TOWN OF BAY HARBOR ISLANDS PLANNING AND ZONING BOARD

FINAL AGENDA

**TOWN OF BAY HARBOR ISLANDS
COMMUNITY DEVELOPMENT
MEMORANDUM**

Subject: Site Development Plan Application – Revision #1
10301 EBHD – 10 DU Multi-Family Residential Complex
10301 E. Bay Harbor Drive
Bay Harbor Islands Acct. No. MB2016-66
MMPA Acct. No. 01-0702-1038

Date	01/20/2018
PLAN LEVEL 09	
0A-09 R

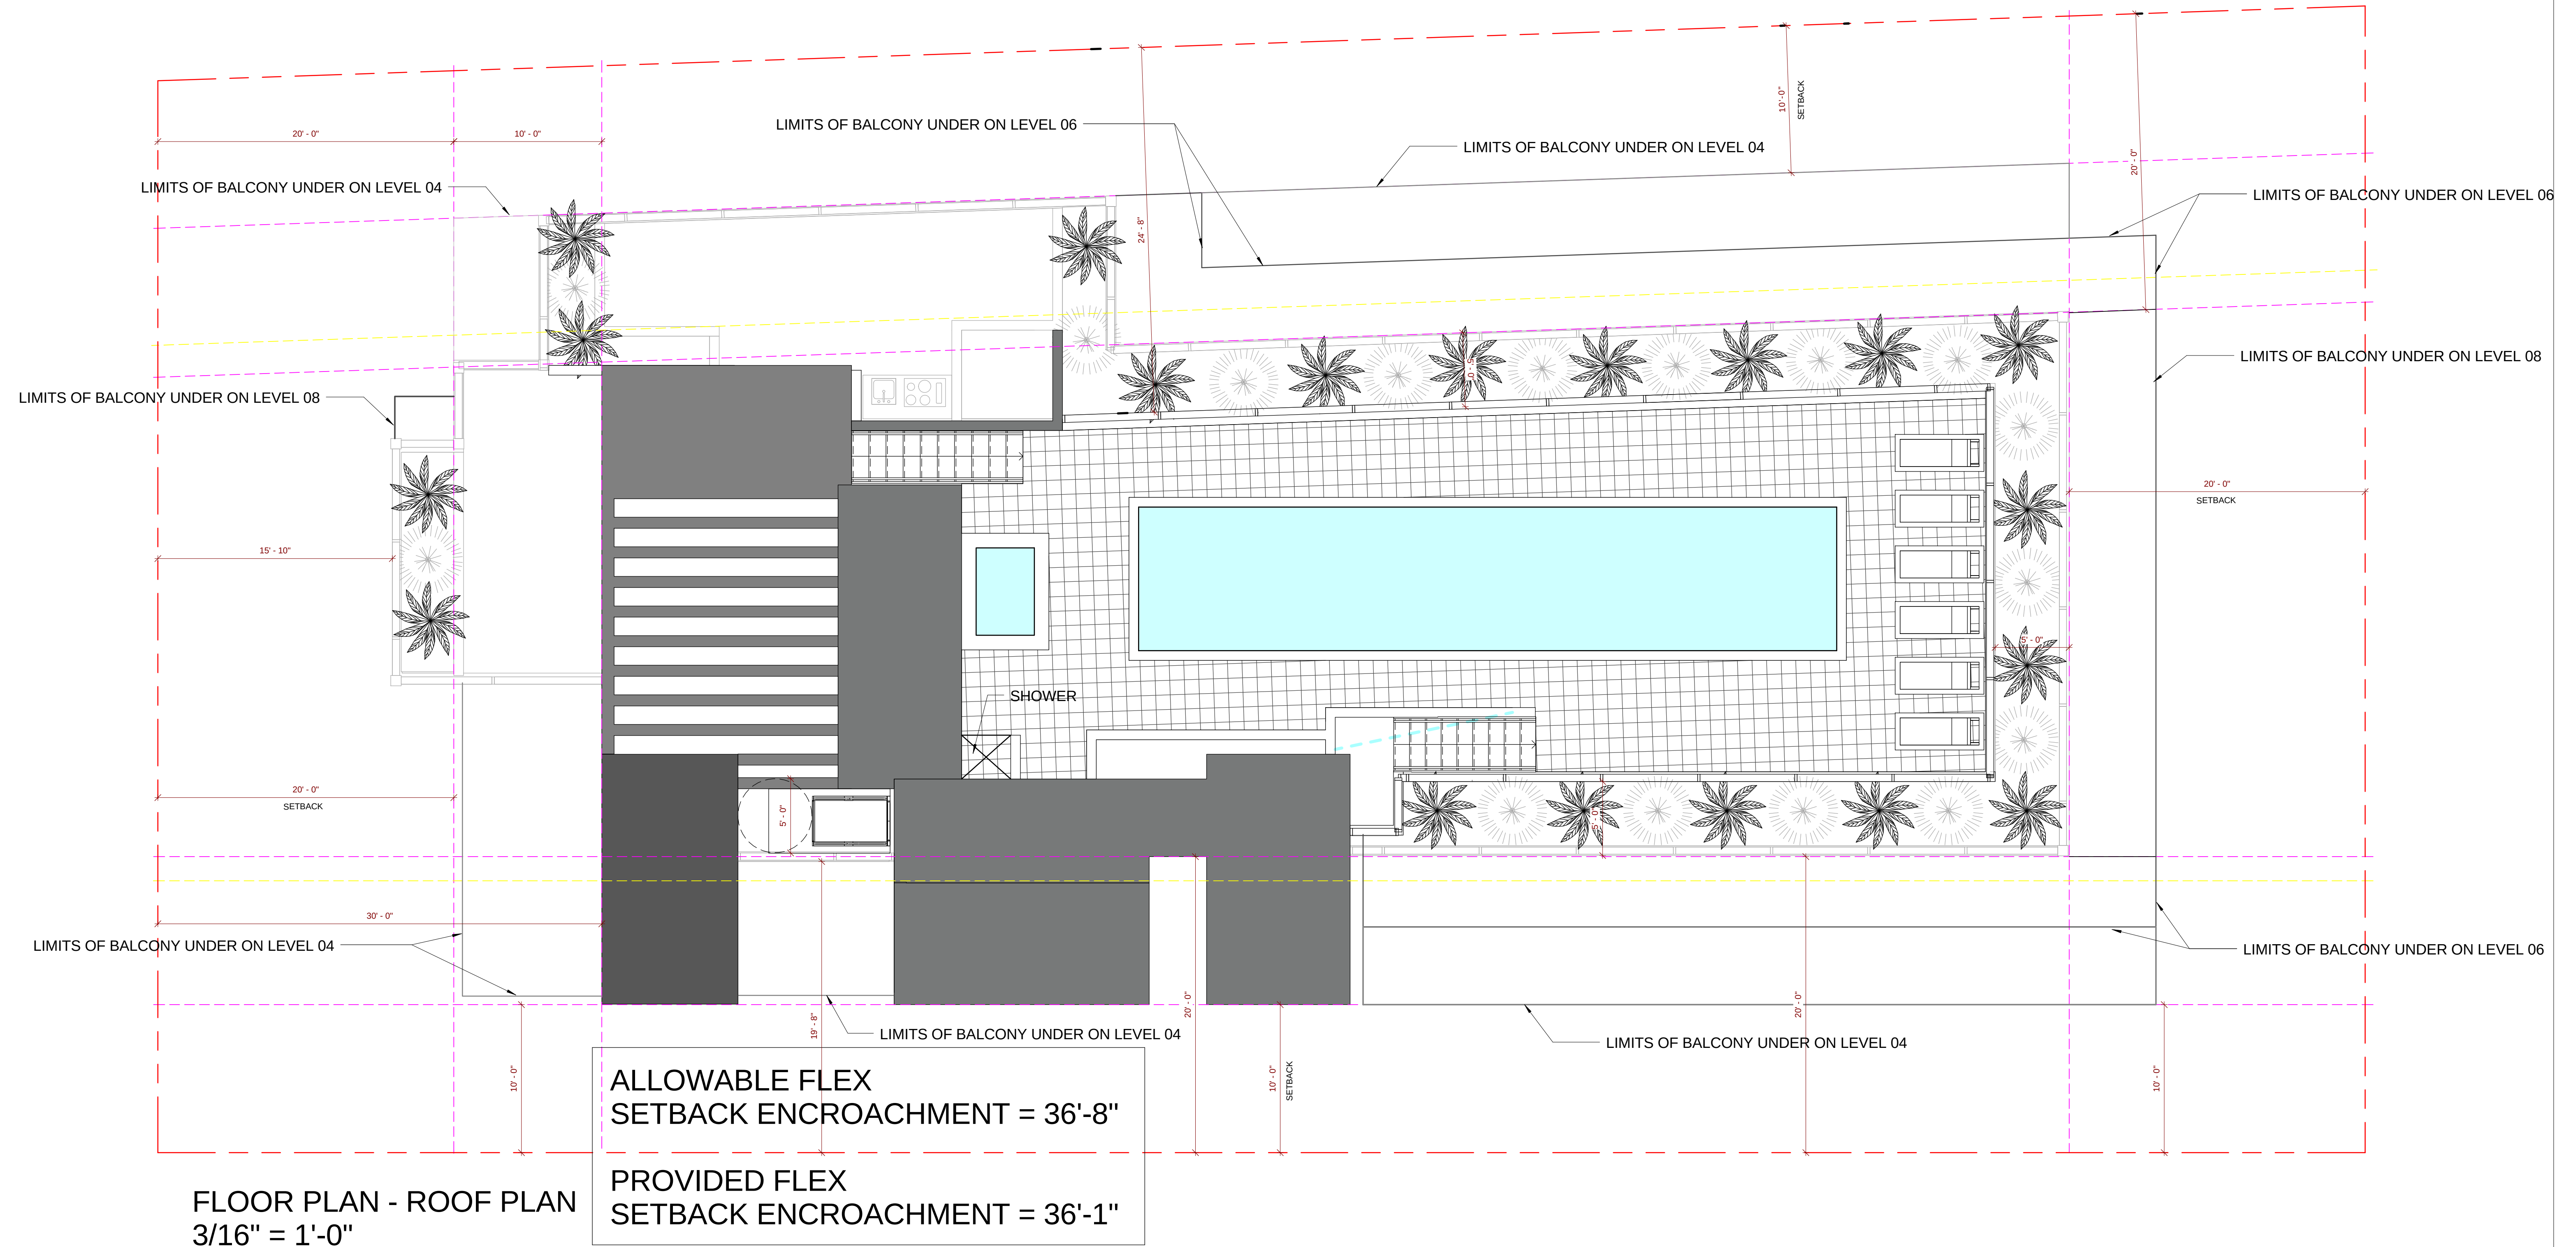
ADD RAILING AND GLASS IN PENTHOUSE UNIT TO ROOFTOP TERRACE-REFER TO SHEETS OA-09 & OA-22

REPLACE SLIDING ROOF COVERINGS FOR FITNESS AREA WITH TRELLIS AND TRY TO LOWER STAIR BULKHEAD TO MATCH EXISTING-REFER TO SHEETS OA-09 AND OA-22

Date	01/20/2018
ELEVATIONS WEST/EAST 0A-22 R

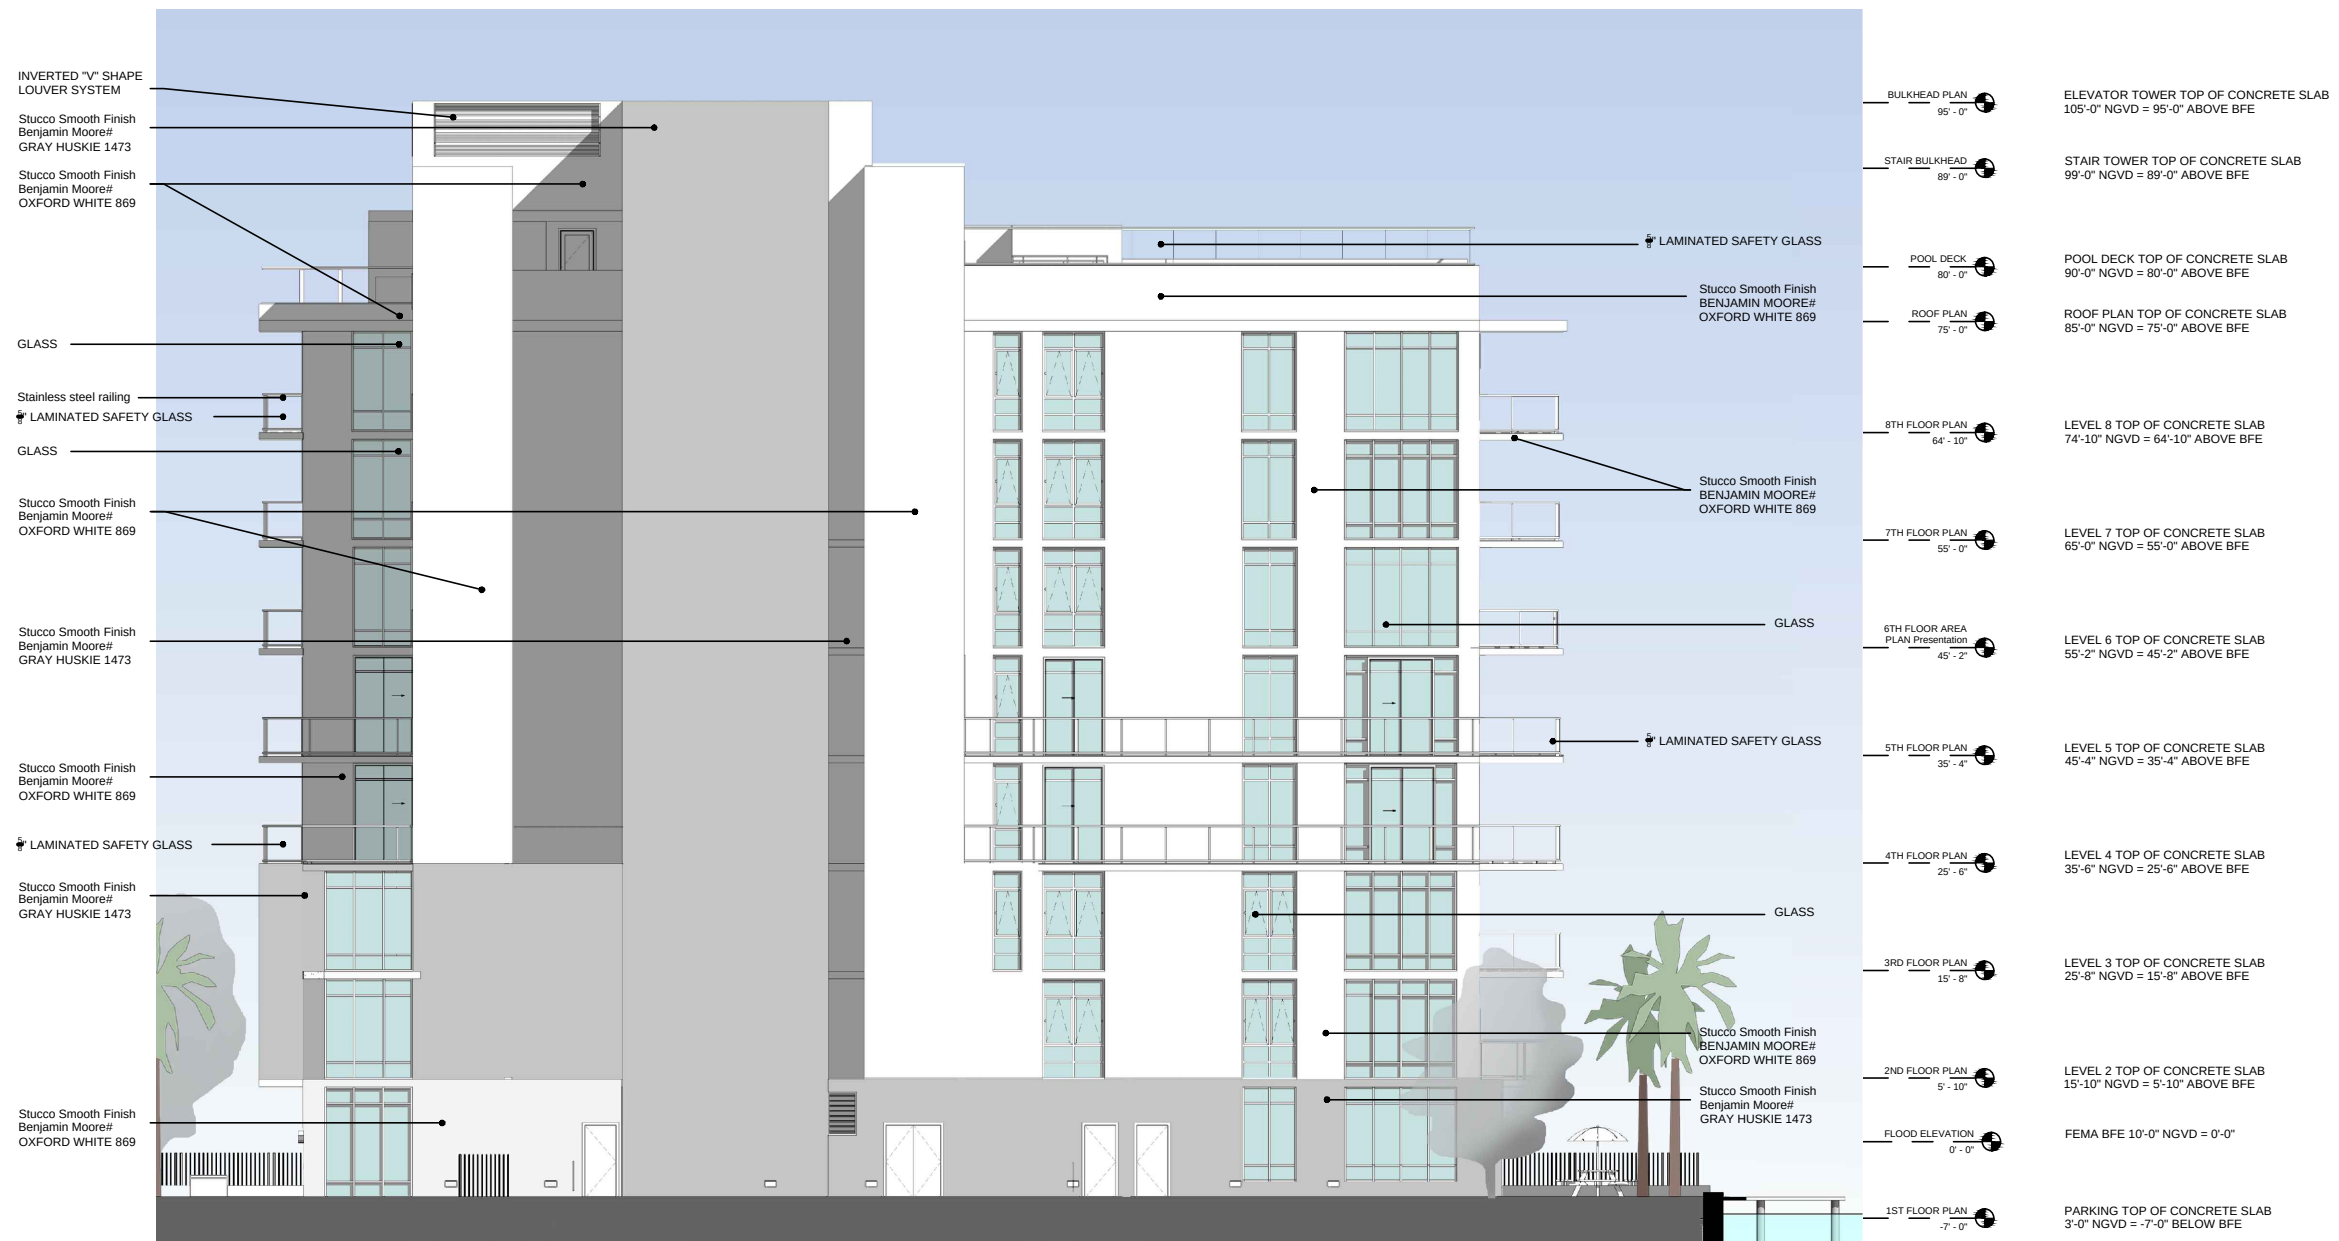
REDESIGN EAST FACADE AT GARAGE LEVEL TO MAKE IT LOOK LESS LIKE A GARAGE DOOR AND INTRODUCE LOUVERS THAT WRAP FROM EAST TO NORTH SIDE AS A BAND-REFER TO SHEET OA-22

EXPRESS VERTICAL LINES IN EAST ELEVATION TO CARRY DOWN GLAZING FROM ABOVE TO GROUND LEVEL-REFER TO SHEET OA-22

ALIGN WINDOWS ON NORTH ELEVATION BY MASTER BEDROOMS TO MATCH VERTICAL LINES BELOW-REFER TO SHEET OA-22

ALIGN WINDOWS ON SOUTH ELEVATION BY MASTER BEDROOMS TO MATCH VERTICAL LINES BELOW-REFER TO SHEET OA-22

RELOCATE FPL TRANSFORMER FURTHER TO SOUTH PROPERTY LINE; NOTE: ADJUST LANDSCAPING-REFER TO SHEET OA-22
